Department of Energy
Carlsbad Field Office
P. O. Box 3090
Carlsbad, New Mexico 88221
November 1, 2004

Subject: Initial Response to Environmental Protection Agency (EPA) September 2, 2004, Letter on Compliance Recertification Application

Figure 1. Piper diagrams for samples collected from WQSP wells from 1995 through 2002

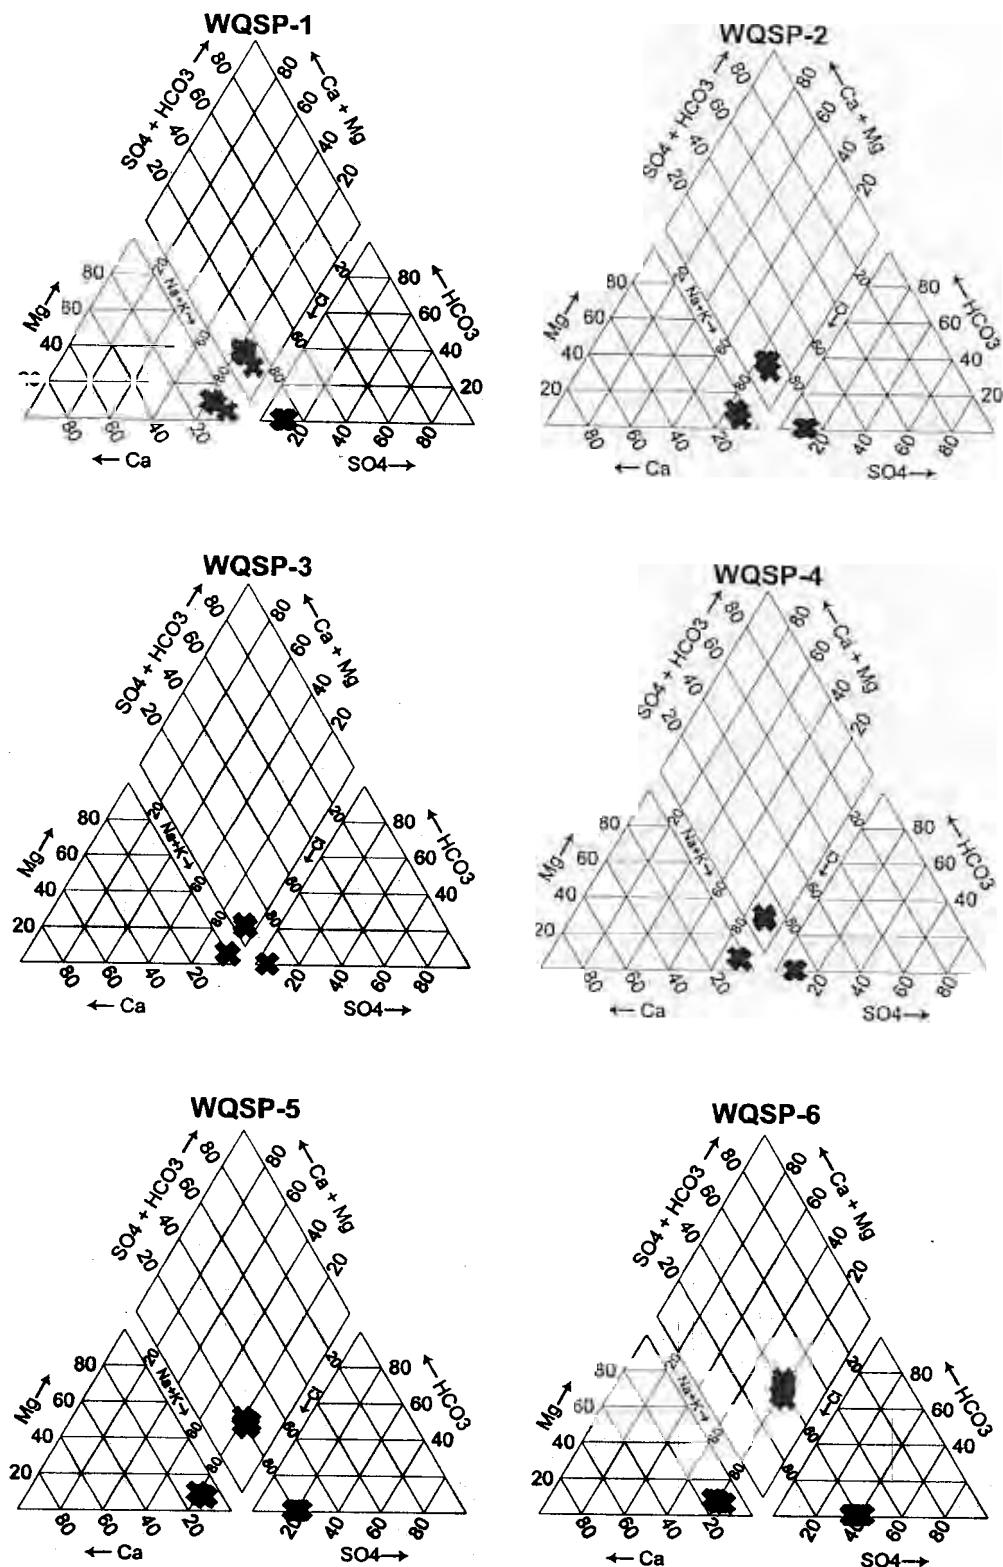
DOE has removed discussion of all "background" environmental conditions, but does not address how information obtained since the approval of the CCA may have affected these "background" conditions. For example, groundwater monitoring has occurred for several years, yet the discussion pertaining to Water Quality remains unchanged with respect to the hydrochemical facies.

The discussion pertaining to water quality has not changed since the CCA because monitoring has detected no changes in groundwater quality. Figure 1 shows Piper diagrams with the results of 15 rounds of sampling at the WQSP Culebra wells conducted between 1995 and 2002 (WRES 2003). The first 10 rounds (collected through May 2000) were used to establish baseline concentrations of the major ions (IT Corporation 2000). No changes to the baseline hydrochemical facies were observed over the five subsequent rounds of sampling. WRES (2003) presents time-trend plots for the major ions and other water-quality parameters for all 15 rounds of sampling, showing the absence of changes from the baseline values.

Figure 2-57. Seismic events with a magnitude greater than 3.0 within 150 miles of the WIPP site.

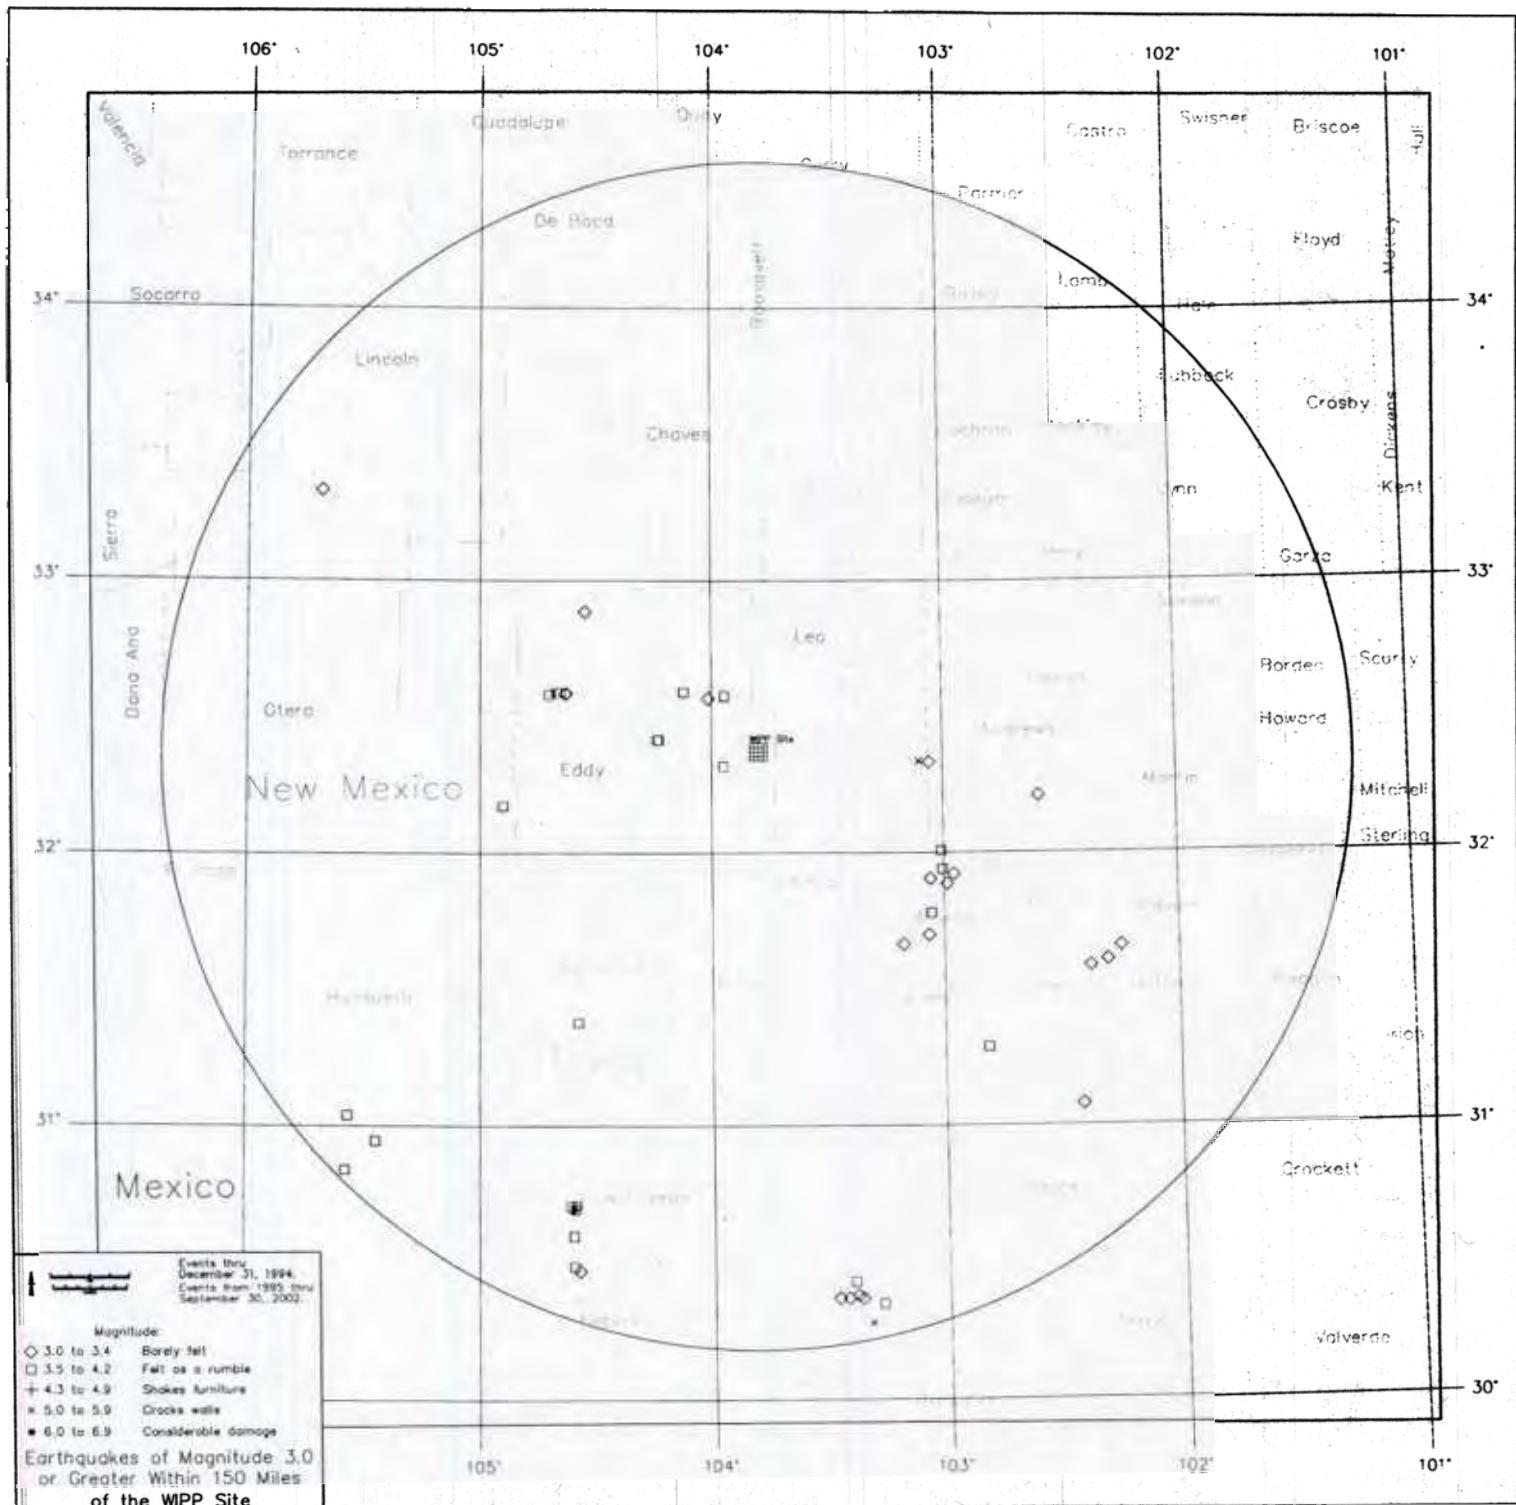
The CRA includes a discussion of seismicity in the WIPP vicinity, but does not discuss post-CCA seismic events. If no events occurred, the CRA should so state. Additionally, Figure 2-57 does not clearly present events that are “post CCA”, even though the title of the figure implies that it includes these events. DOE needs to identify the seismic events that have occurred since the CCA.

Figure 2-57 has been updated to show the seismic events with a magnitude greater than 3.0 within 150 miles of the WIPP Site. The seismic events in black occurred during the CCA time frame, while the events in red are from the CRA time frame. Also provided is a table that defines the location, the magnitude, the time, and the date of each event in Figure 2-57.
